Service Bulletin

SB 15-2
8/10/87

PRODUCTION CHANGE /
SCHEDA INTRODUZIONE VARIANTE

SUBJECT / OGGETTO: AIR PUMP
VEHICLES / VETTURE TIPO: TESTAROSSA (US & JAPAN VERSIONS)

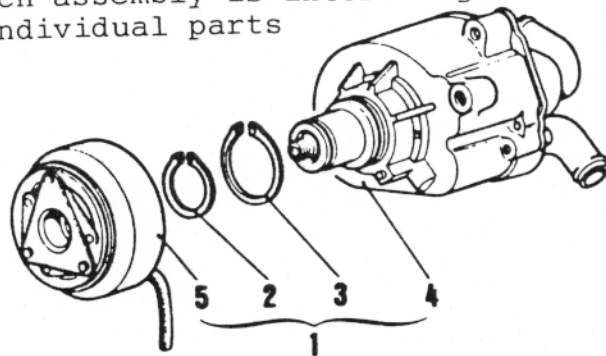
The fastening of the electro-magnetic clutch to the air pump has been modified. The new air pump/clutch assembly is interchangeable with the replaced assembly, but the individual parts are not interchangeable.

For the earlier type Testarossa vehicles, after exhaustion of the replaced parts, it will become necessary to install the new assembly.
